# CITY OF ALBUQUERQUE

**Re: APS Family School East Side**  
**3303 Monroe Street NE**  
**Traffic Circulation Layout**  
Engineer's Stamp 12-12-16 (G17-D019A)

## C-TCL

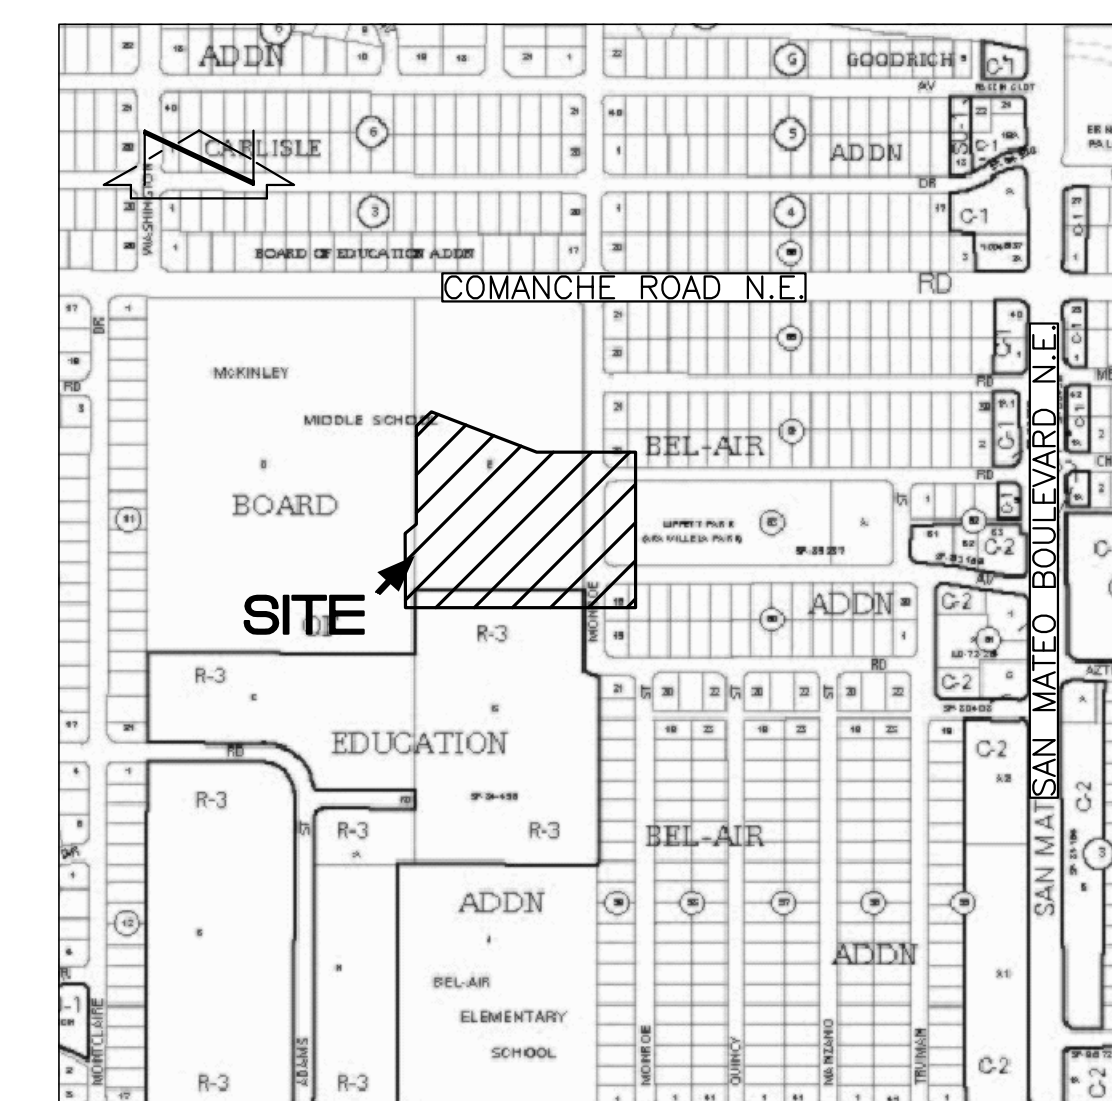
1. Please review and revise plan to provide all information listed on the attached Traffic Circulation Layout checklist.
2. List the number of parking spaces required by the zoning code as well as the proposed number of parking spaces including bicycle and motorcycle parking.

3. Clarify the extents of the current phase. Provide a phasing plan.
4. The traffic circulation layout must be stamped, signed, and dated by an engineer or architect licensed in the state of New Mexico.

5. Identify all existing access easements and rights of way width dimensions.
6. Identify the right of way width, medians, curb cuts, and street widths on Monroe St.

7. Please list the width and length for all existing and proposed parking spaces. Some dimensions are not shown.
8. Please dimension the proposed sidewalk widths.

9. Show all drive aisle widths that effect current phasing. Some dimensions are not shown.
10. Label the compact parking spaces by placing the words "**COMPACT**" on the pavement of each space.

11. The handicap accessible spaces must include an access aisle. Van accessible aisles should be 8ft wide; all others should be 5ft wide.
12. The ADA accessible parking sign must have the required language per 66-7-352.4C NMSA 1978 "**Violators Are Subject to a Fine and/or Towing.**" Please call out detail and location of HC signs.

13. The ADA access aisles shall have the words **"NO PARKING"** in capital letters, each of which shall be at least one foot high and at least two inches wide, placed at the rear of the parking space so as to be close to where an adjacent vehicle's rear tire would be placed. (66-1-4.1.B NMSA 1978)

14. The ADA parking space has a clearly visible, blue, International Symbol of Accessibility painted on the pavement at rear of the space (66-1-4.1.E NMSA 1978) or MUTCD recommends a white symbol on a blue background.

15. Show all drive aisle widths and radii. Some dimensions are not shown.
16. List radii for all curves shown; for passenger vehicles, the minimum end island radius for passenger vehicles is 15 ft. Radius for delivery trucks, fire trucks, etc. is 25 ft. or larger.

17. Provide a min 6" or max 8" high concrete barrier curb or other acceptable barrier between landscaping and parking areas and/or drive aisles. Please call out detail and location of barrier curb.

18. Per the zoning code, a 6 ft. wide ADA accessible pedestrian pathway is required from the public sidewalk to the building entrances. Please clearly show this pathway and provide details.

19. Please specify the City Standard Drawing Number when applicable.
20. Please include a copy of your shared access agreement with the adjacent property owner.
